Application No.
Z-13-07-10
(Rezoning)

Applicant
Flowbake North Port, L.L.C. /
CG to PD, US 41 at Bowman Terrace

Community Development Department Staff Report for Z-13-07-10

Re: DRC-PD-13-01 Concept Plan
Flowers Bakery
July 25, 2013 agenda

ELEVATIONS

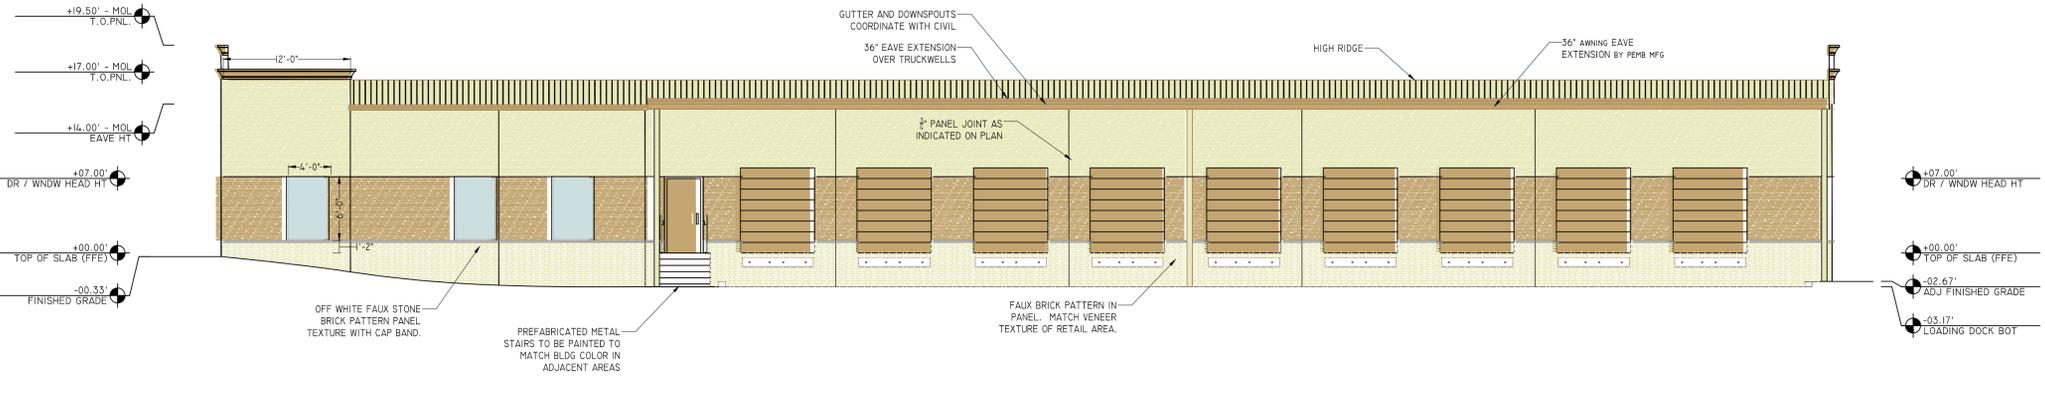
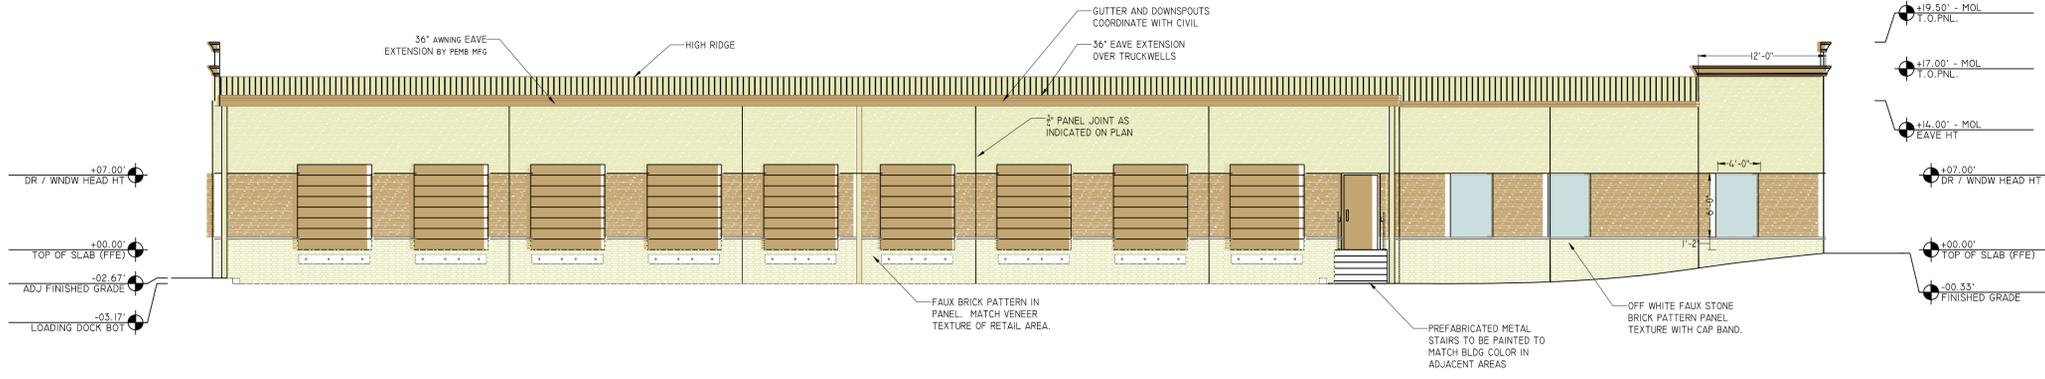
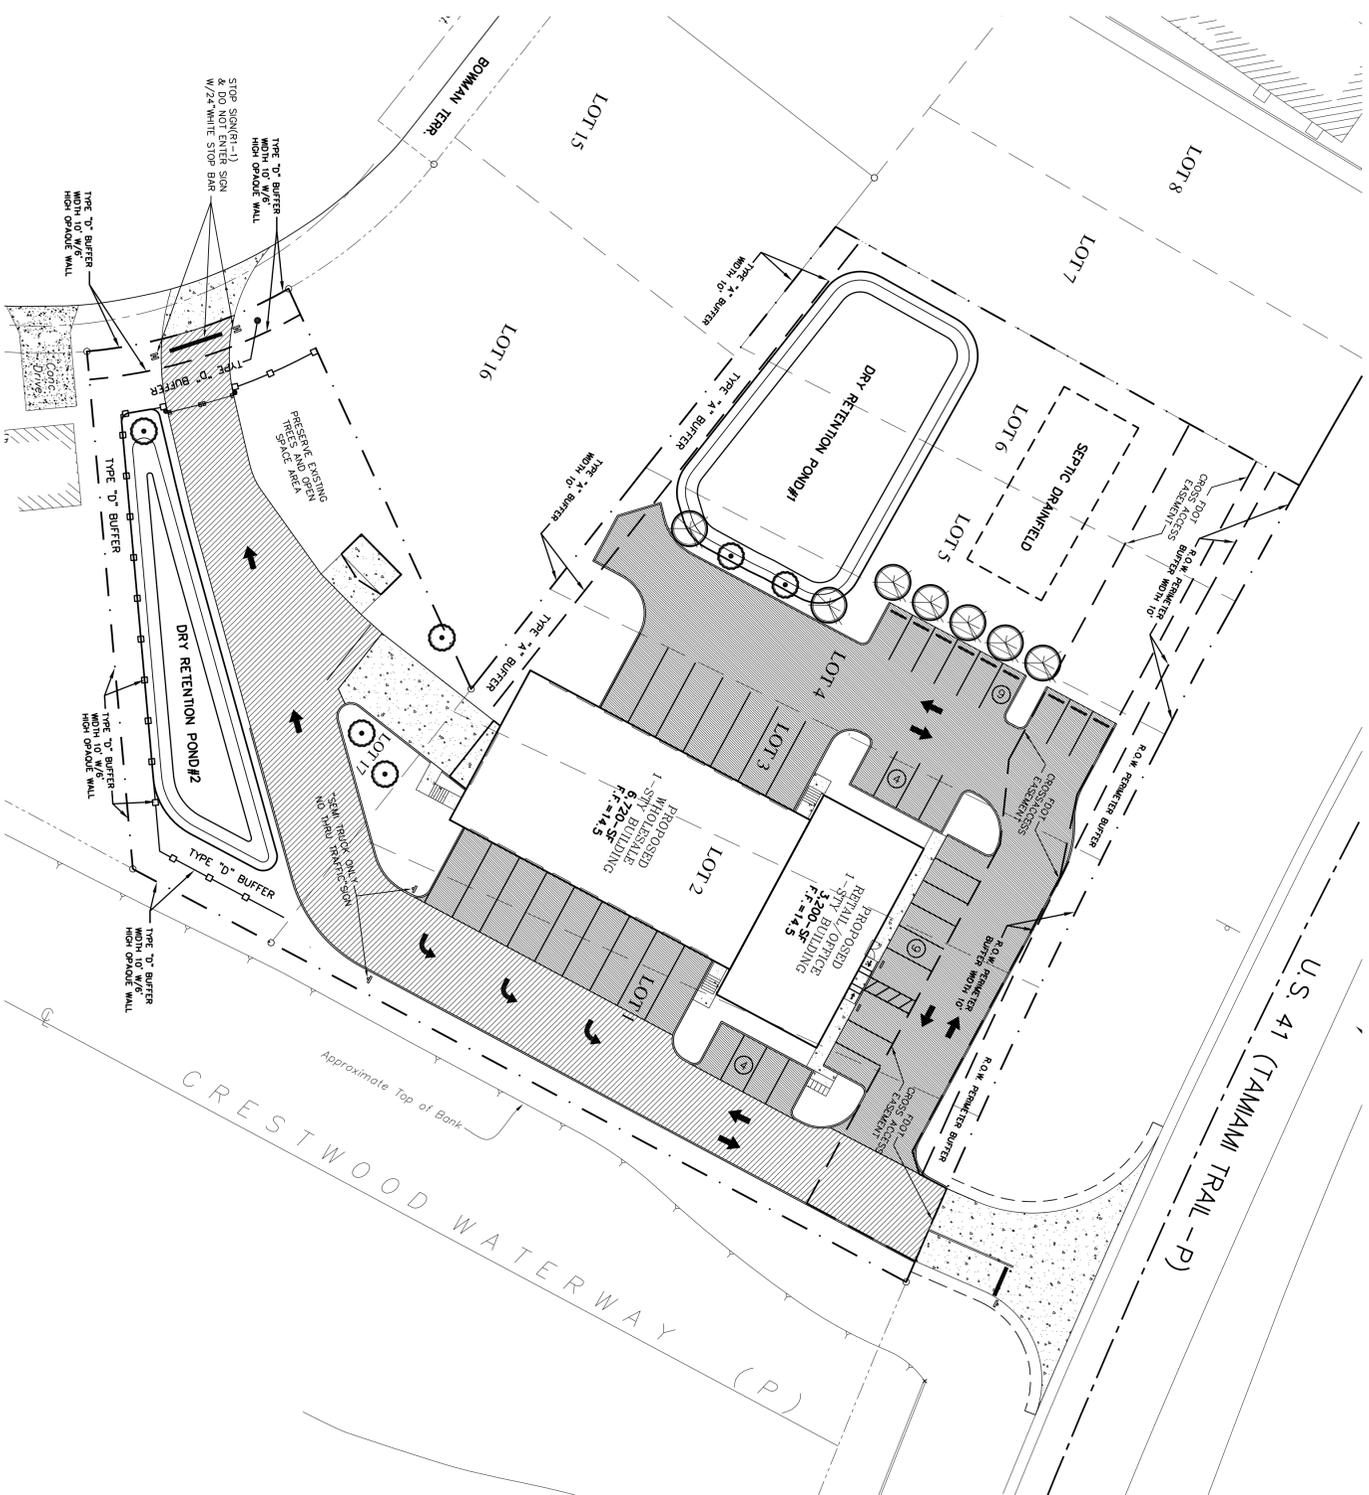
- c. The maximum building height is 38 feet from base flood elevation.
- d. This development is subject to the provisions of Chapter 3-5, Article XXIV, Charlotte County Commercial Design Standards. At a minimum, the architectural features and elevation of this project shall meet the graphic shown on Attachment 1 of this staff report, “Flower Bakery New Facility Elevations”.
